ADDENDUM NO. 2
 August 27, 2019

PSJA ISD Softball and Baseball Field Upgrades
PSJA ECHS ~ PSJA MEMORIAL ECHS~ PSJA NORTH ECHS ~ PSJA SOUTHWEST ECHS
PHARR-SAN JUAN-ALAMO INDEPENDENT SCHOOL DISTRICT

PBK Project No.: 19141SP

ISSUE FOR PROPOSALS
**BASEBALL
IRRIGATION PLAN**
CA 105

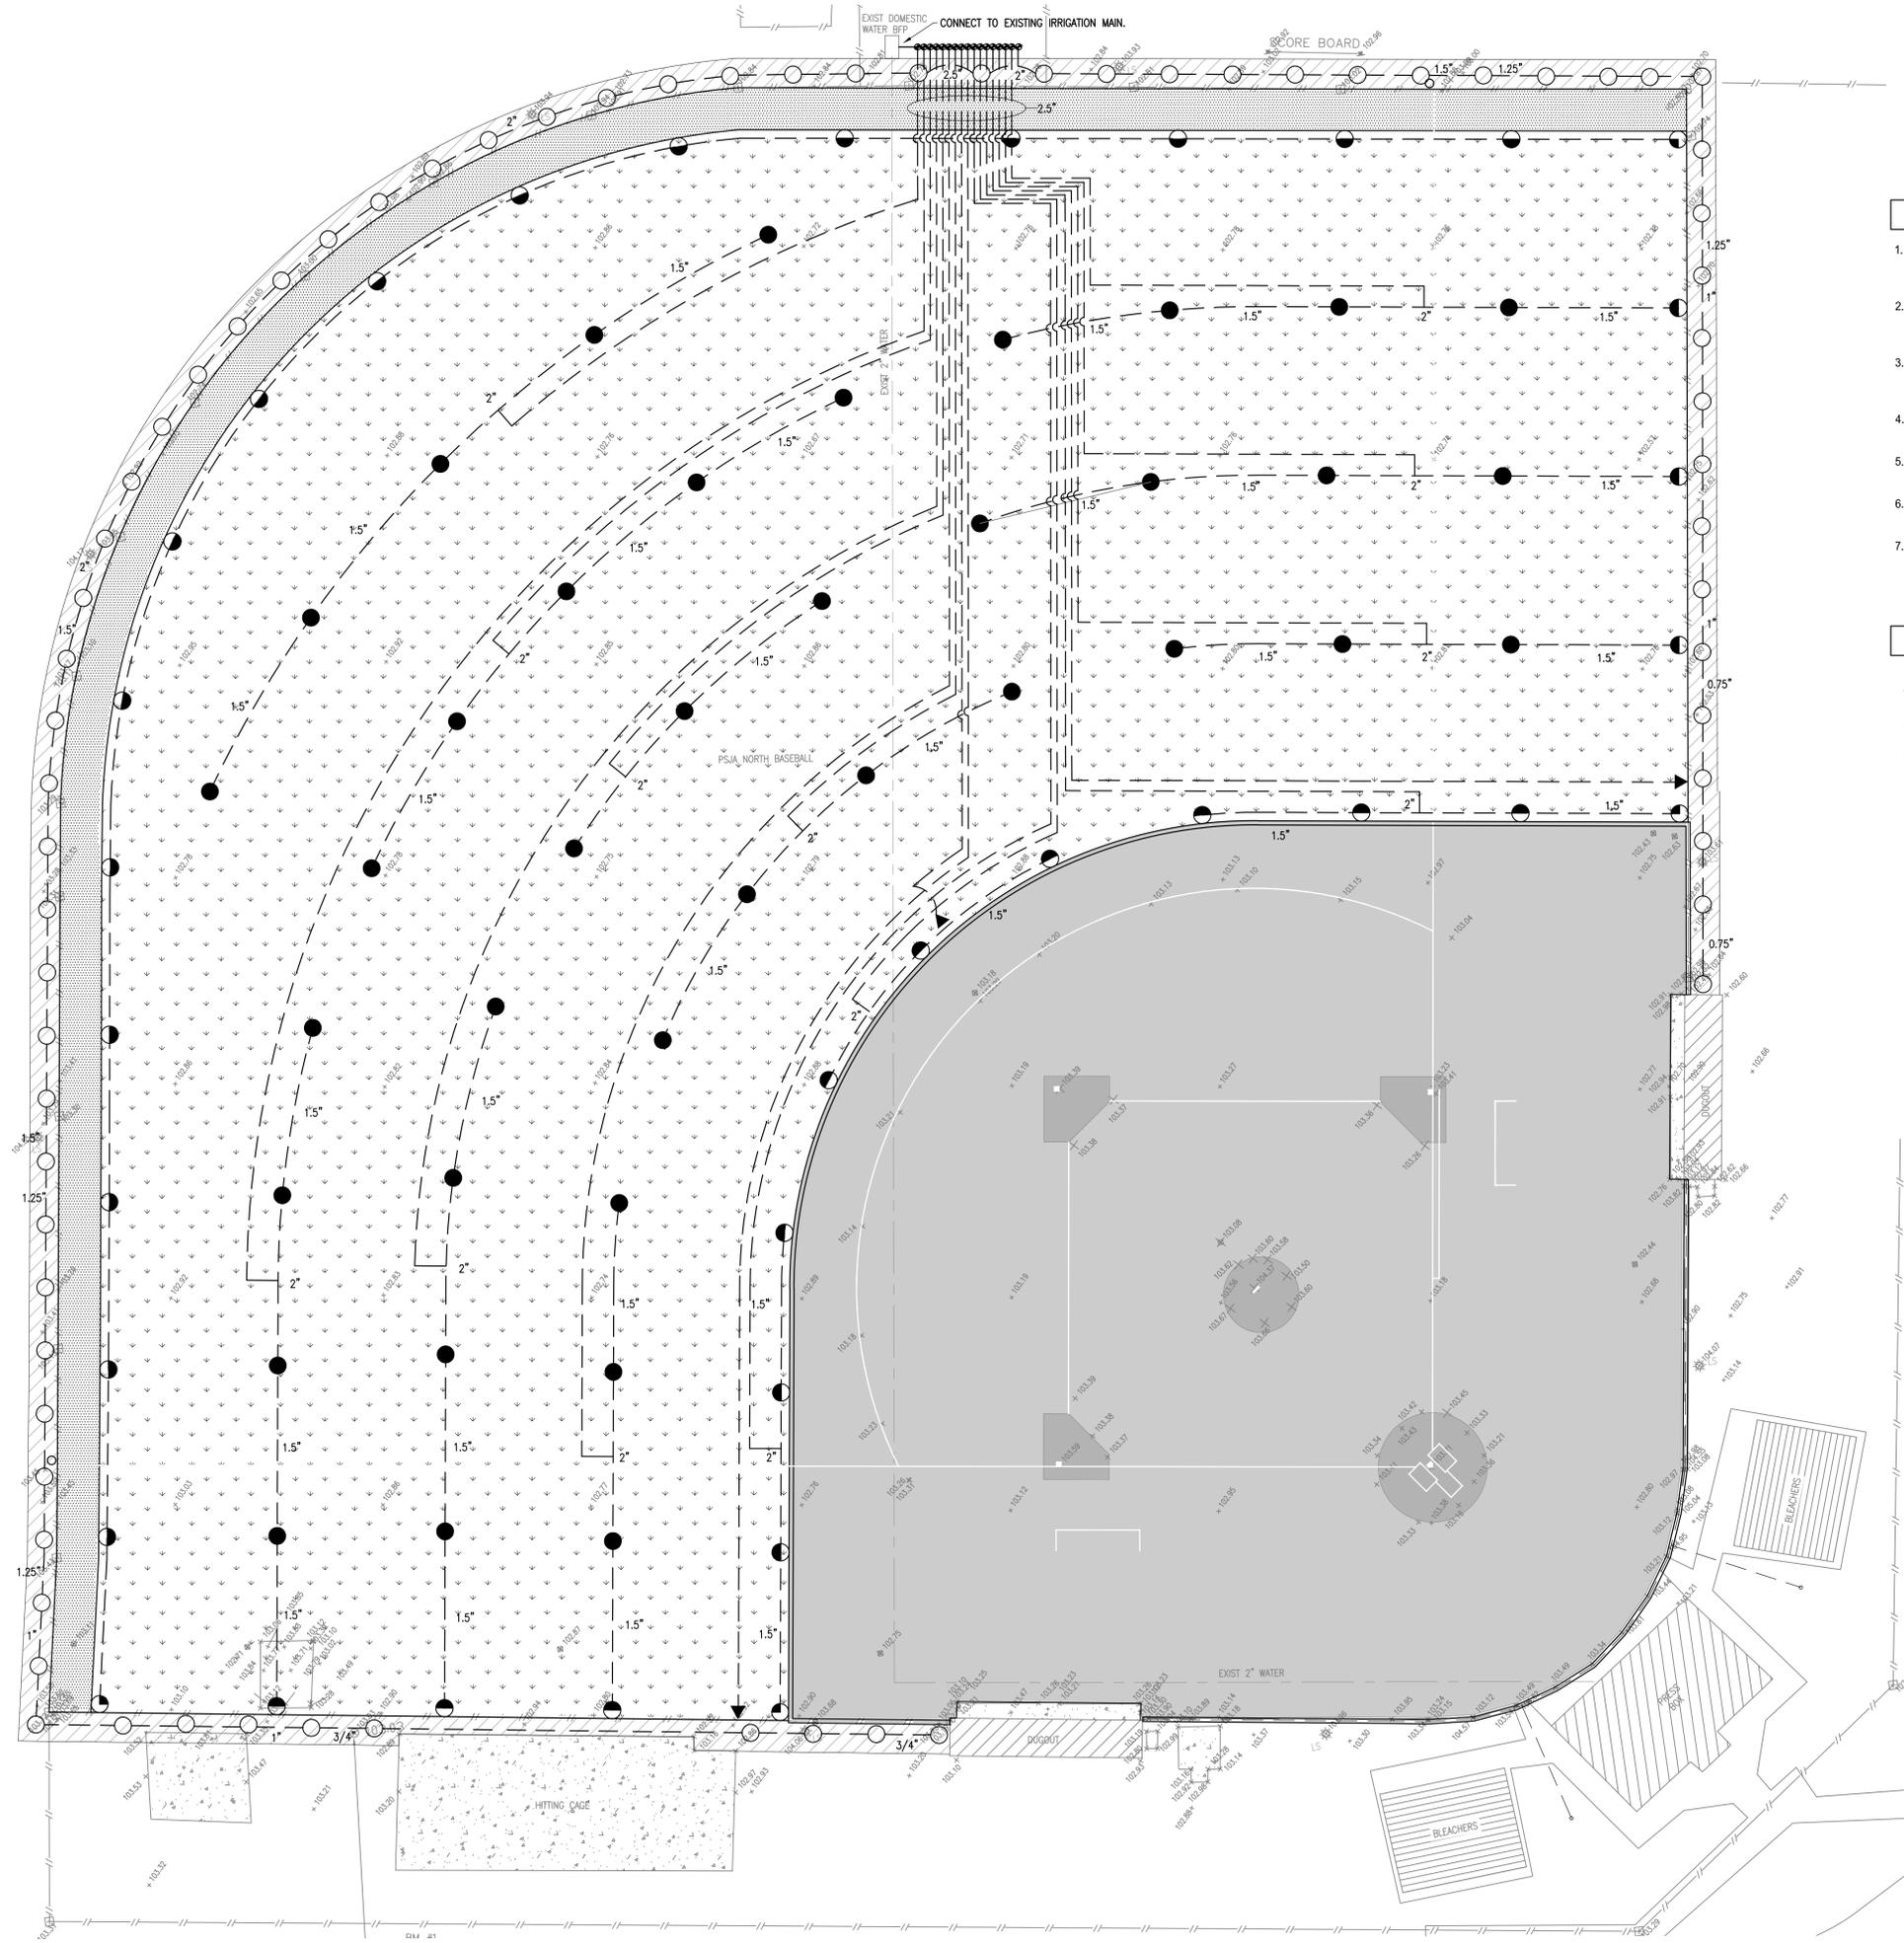
Item No. 6 **The irrigation plans for all fields only show locations of the irrigation heads and lateral lines. The legend indicates that the following should be show on the plan: • Rainbird PEB series electric valve • Isolation valve • Backflow device • Meter These items are not show on any of the irrigation plans. Please provide revised irrigation plans showing the missing items listed above.**

Item No. 8 **CA 105 BASEBALL IRRIGATION PLAN**

Response: See attached for the updated baseball field irrigation plans. At all fields, including both baseball and softball, the existing backflow device and meter will remain in place and in use. There is no proposed backflow device or meter in the project scope. The electrical and isolation valves are shown on the plans. There shall be a 1-1/2" PEB series valve for each zone as shown on the irrigation plans. Each quick coupler shall have a 1-1/2" isolation valve in lieu of an electric valve, as shown.

Replace in its entirety. Add pipe sizes, Quick Couplers and information on connection to existing irrigation main. See attached.

ISSUE FOR PROPOSALS
BASEBALL
IRRIGATION PLAN
CA 105

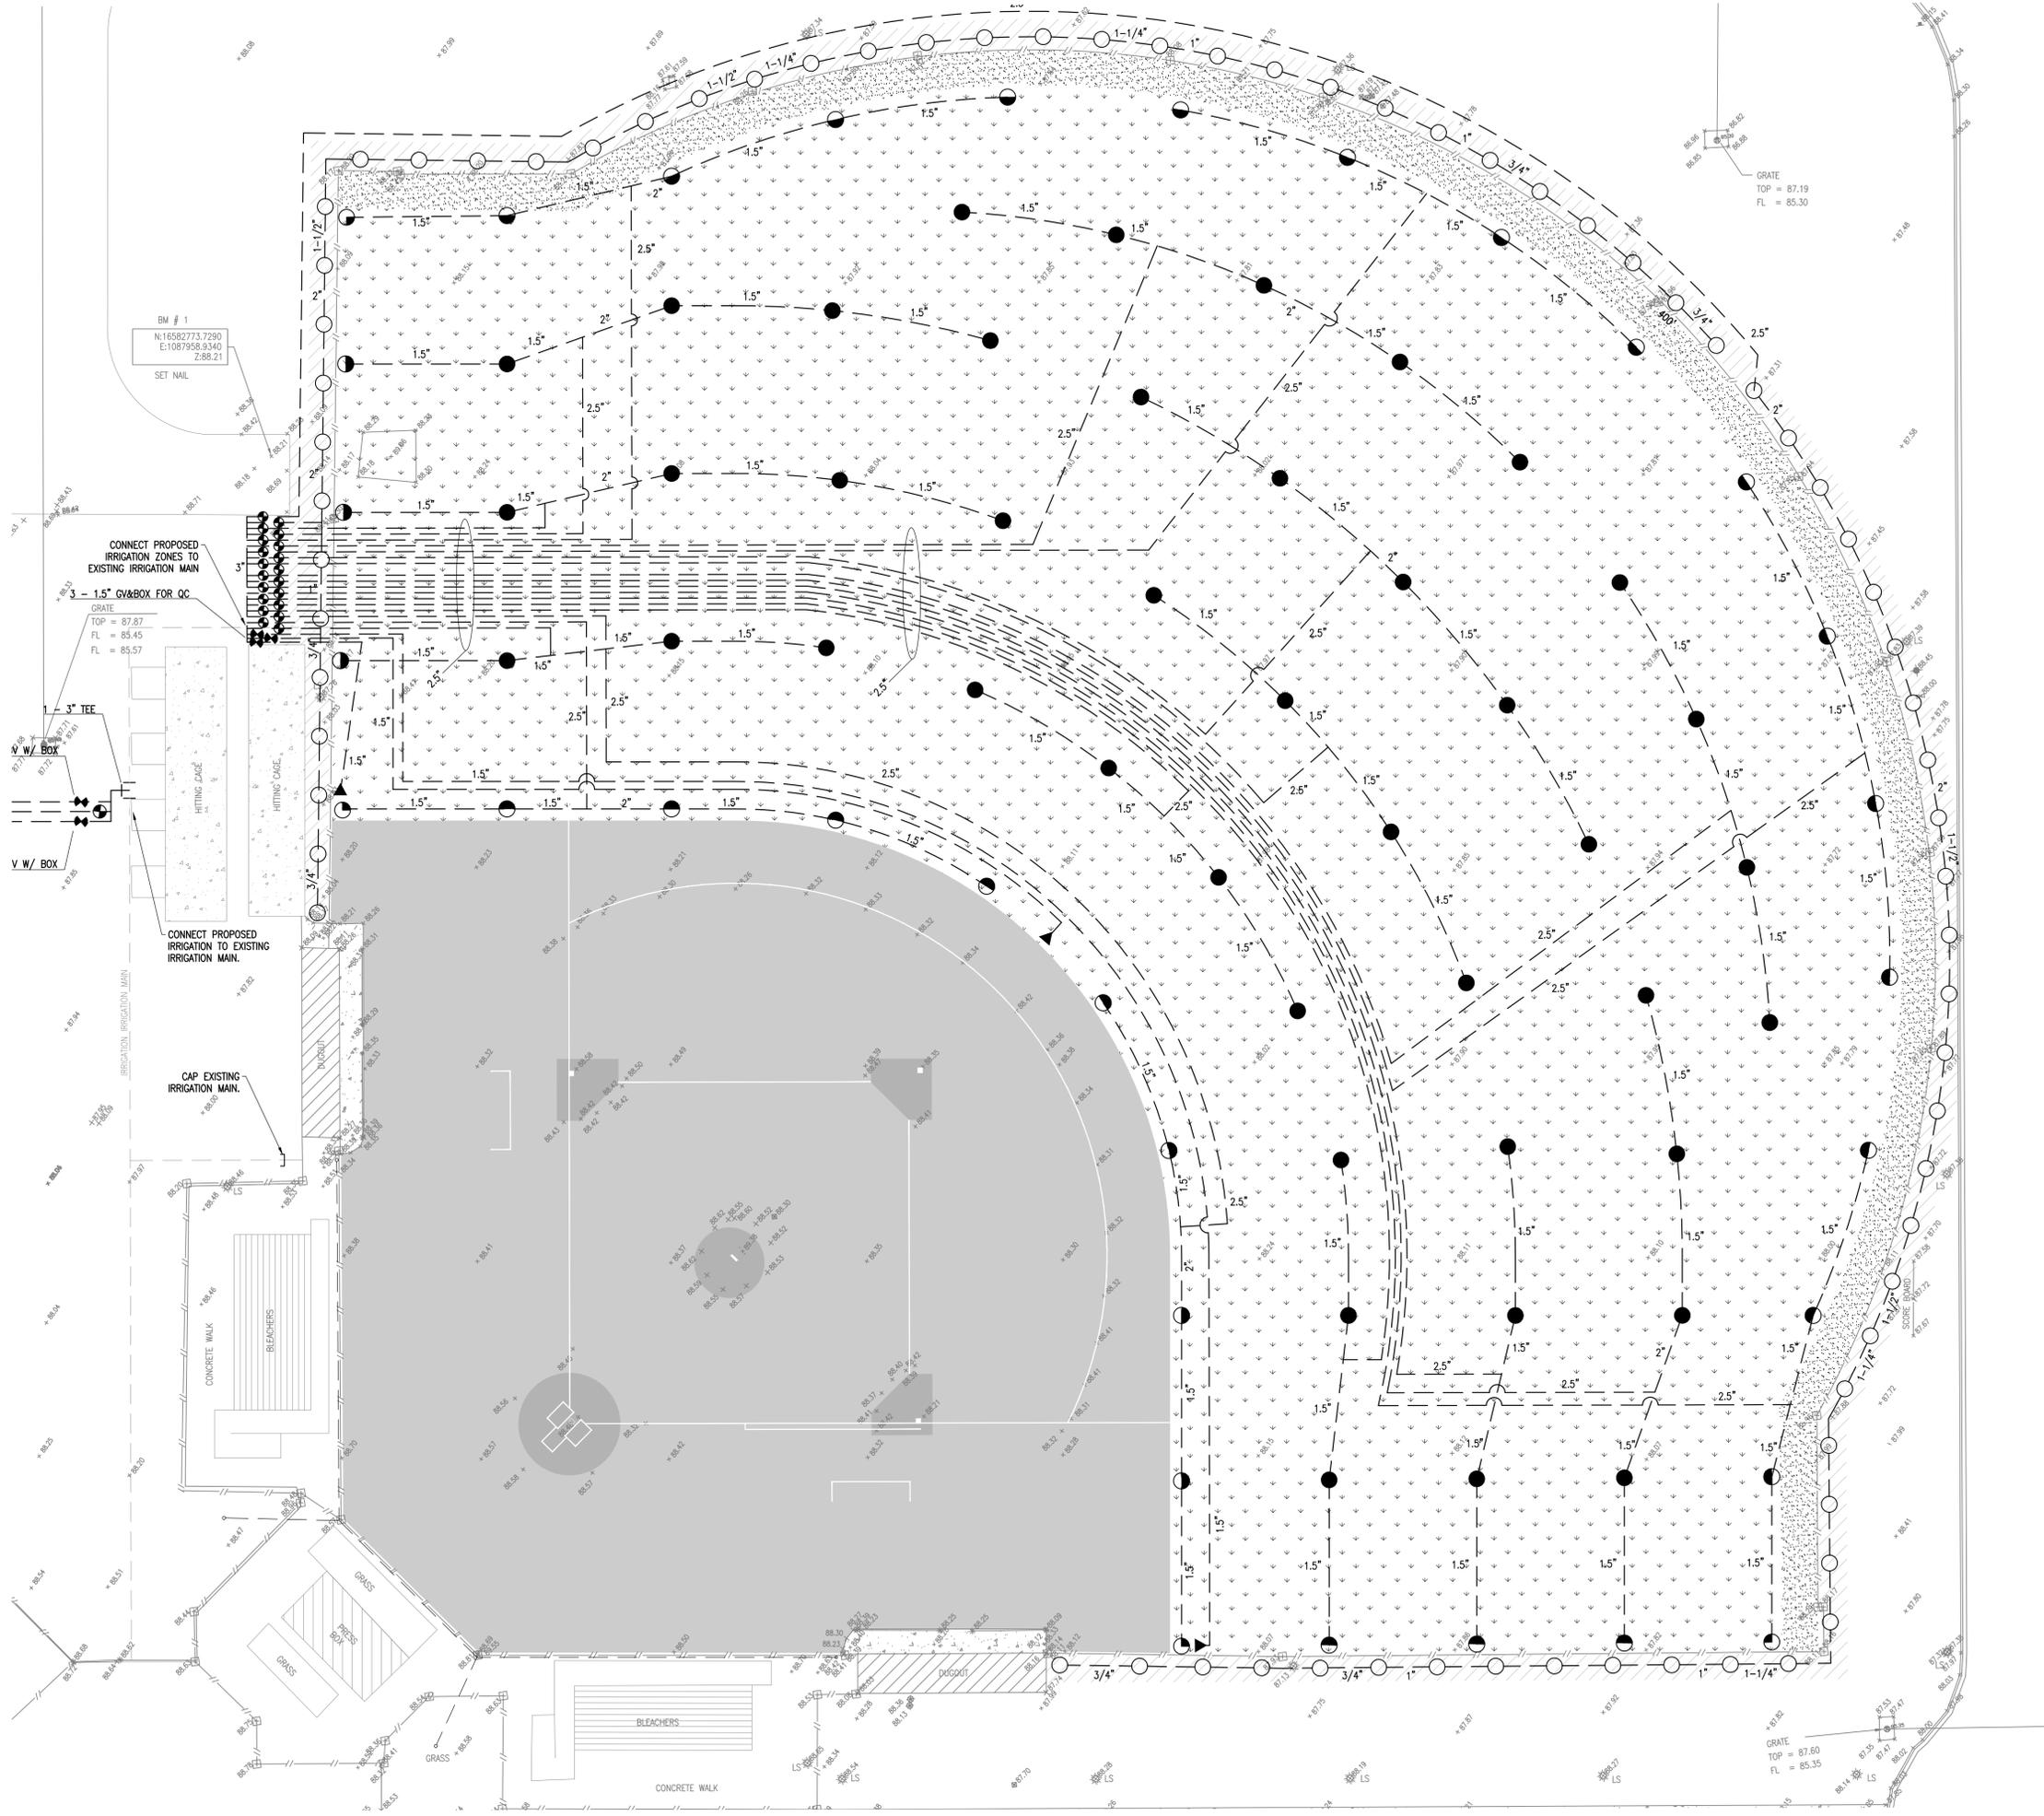
Item No. 9 **CA 105 BASEBALL IRRIGATION PLAN**

Replace in its entirety. Add pipe sizes, Quick Couplers and information on connection to existing irrigation main. See attached.
